APPLICATION
FOR PERCOLATION TESTING AND SITE EVALUATION

Re: **Percolation Test Report**  
Kogan Trust Property  
1965 Long Corner Rd.  
Mt. Airy, Maryland 21771

PERCOLATION TEST PLAN  
LOT 13  
**KOGAN TRUST PROPERTY**  
PLAT No. 10012  
1965 LONG CORNER ROAD

**PERCOLATION CERTIFICATION PLAN**  
 LOT 13  
**KOGAN TRUST PROPERTY**  
 PLAT No. 10012  
 1965 LONG CORNER ROAD

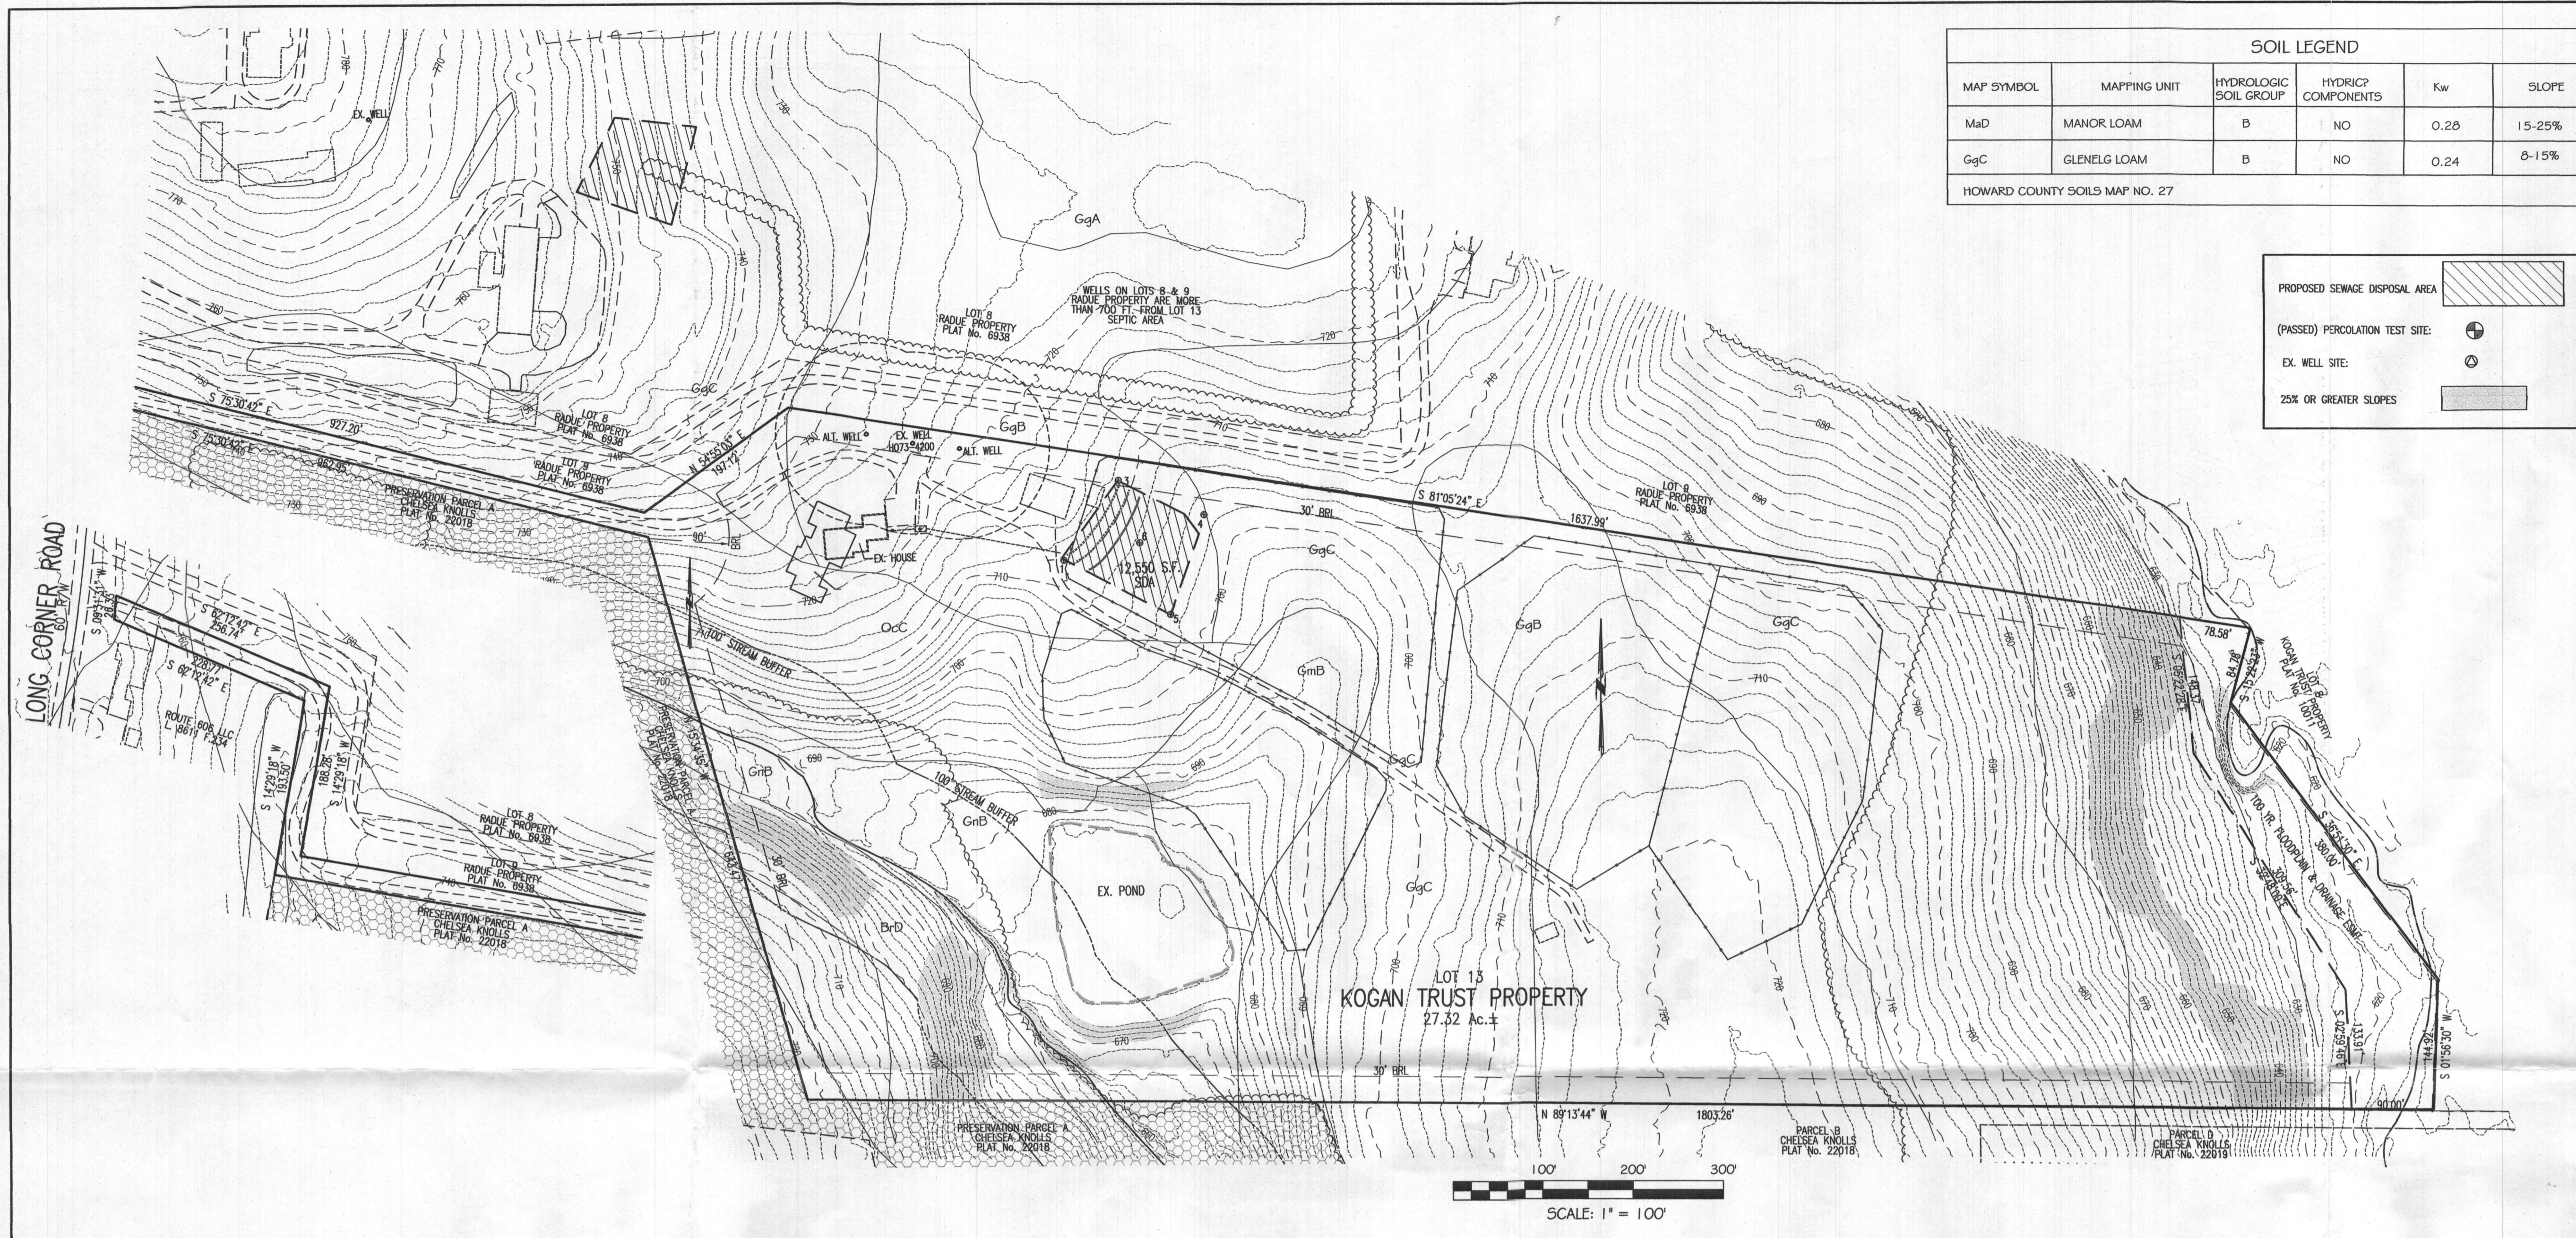
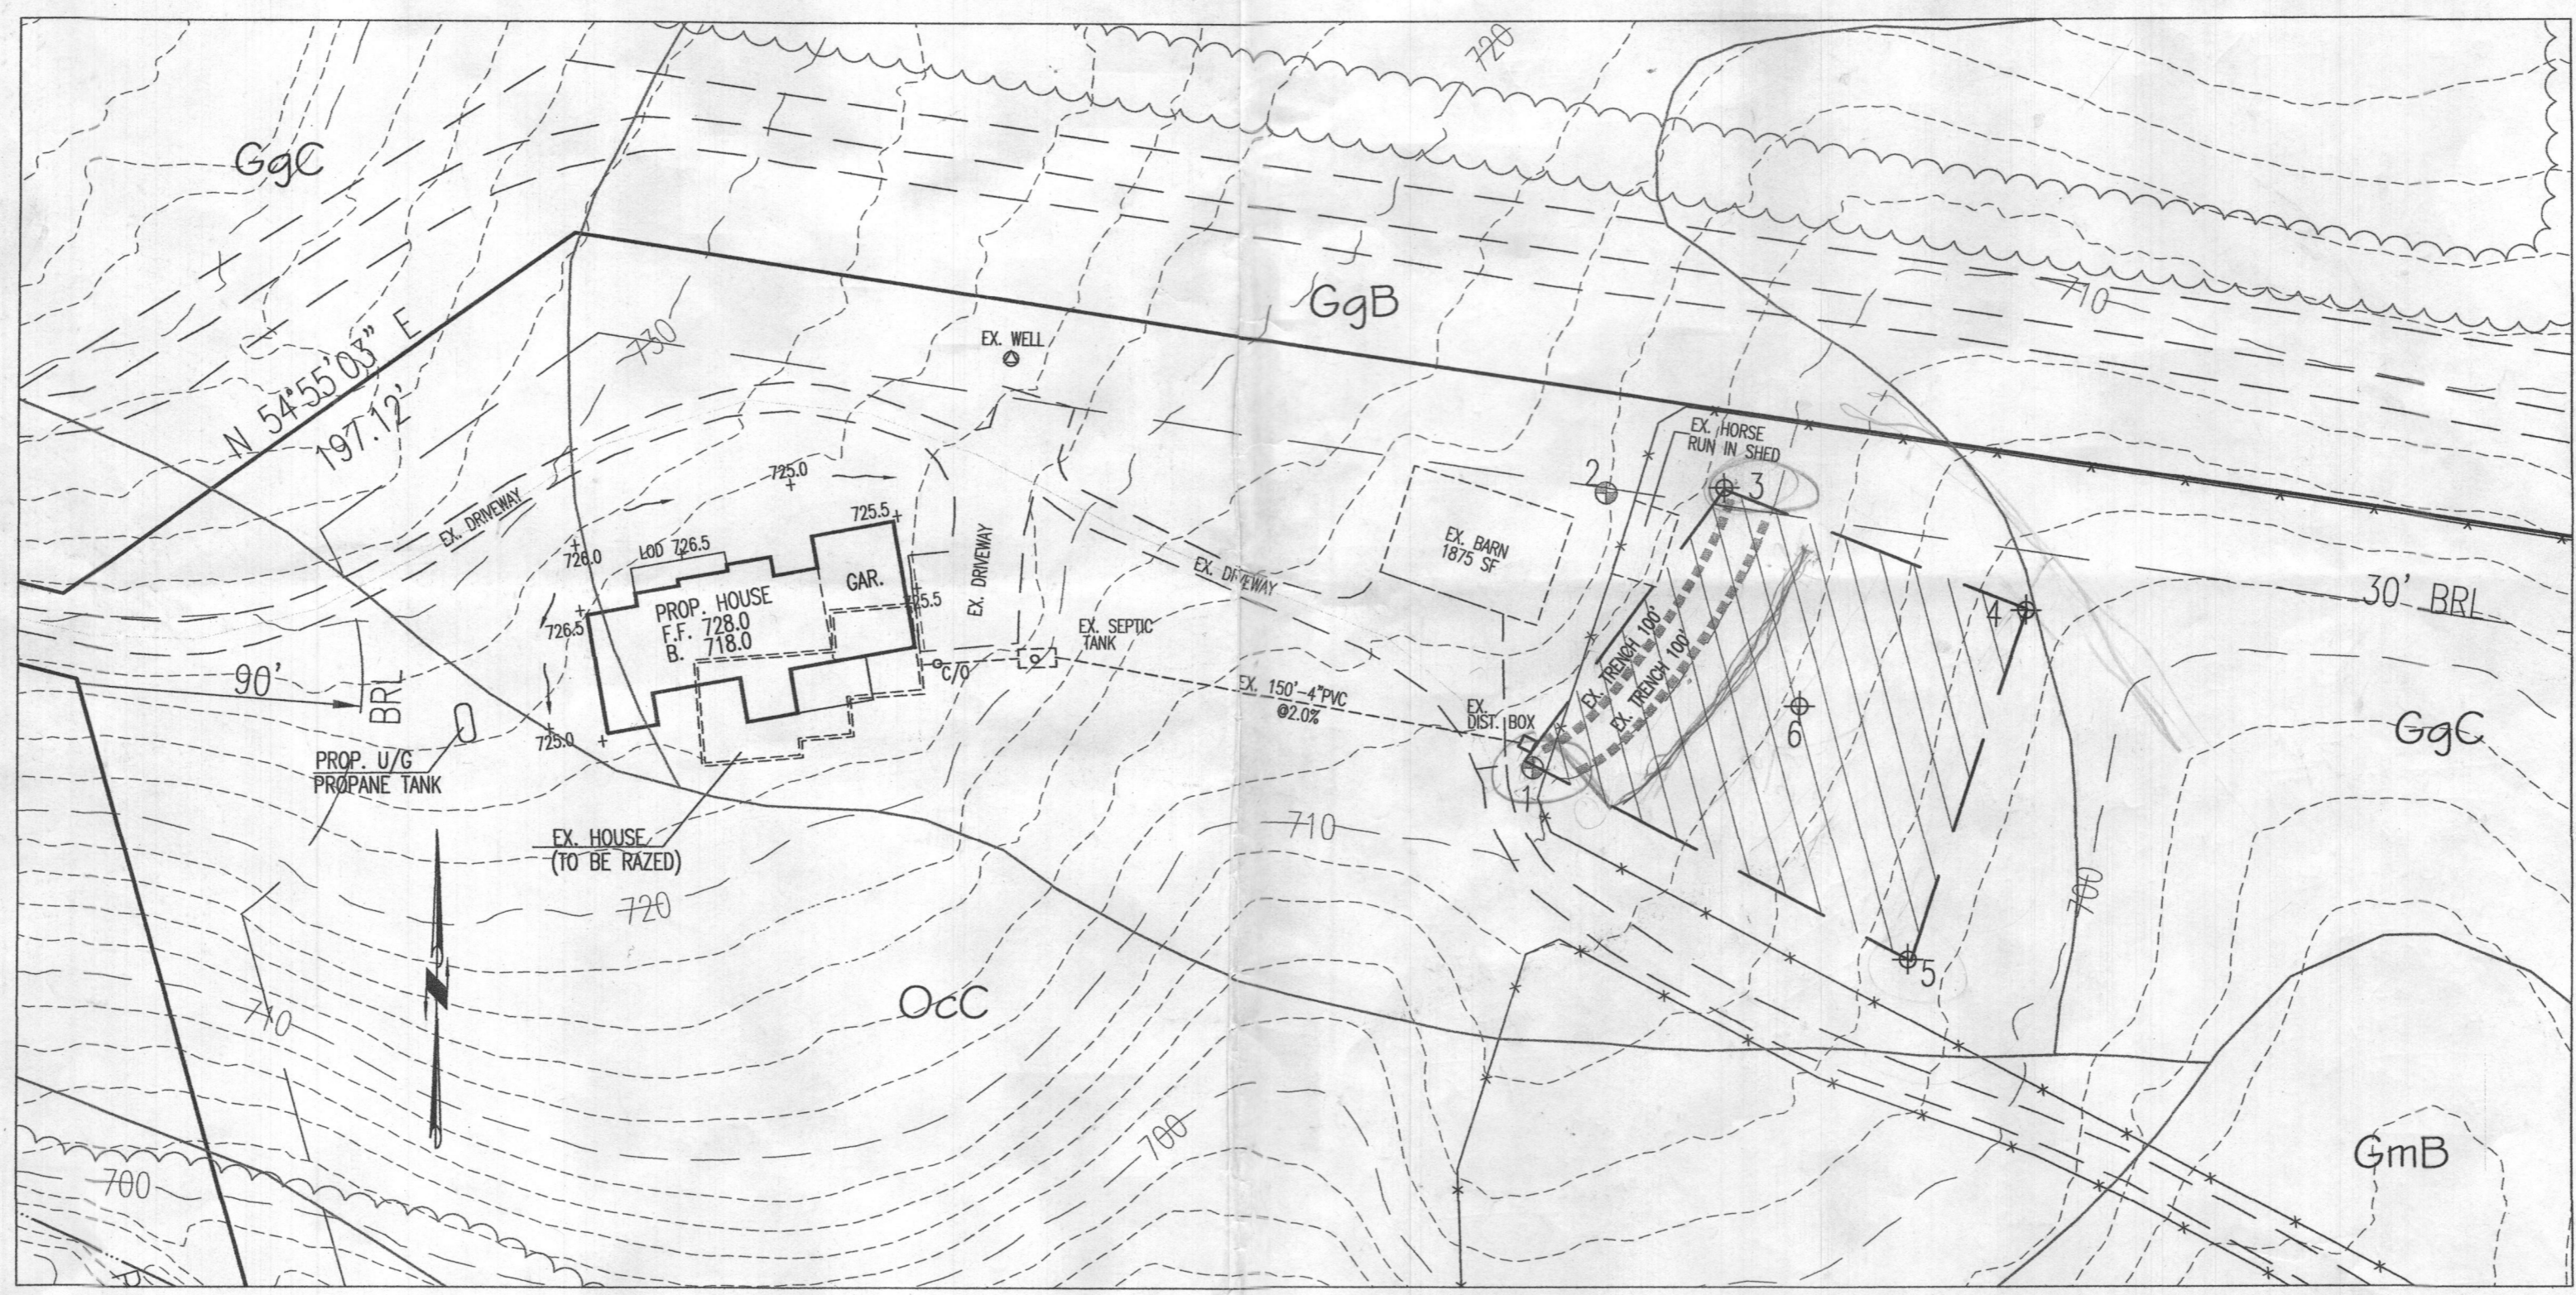
- Needs Alt Well sites or 1500 gft Well Box  
★ - Need 4ft (12')  
- Check Stone in Trenches  
- Check ST size  
- 25' from Slope

15. OSDS plan must be submitted and approved prior to building permit approval.  
 Existing trenches will be evaluated during new trench install. Additional trenching may be needed if found to be hydraulically failing.
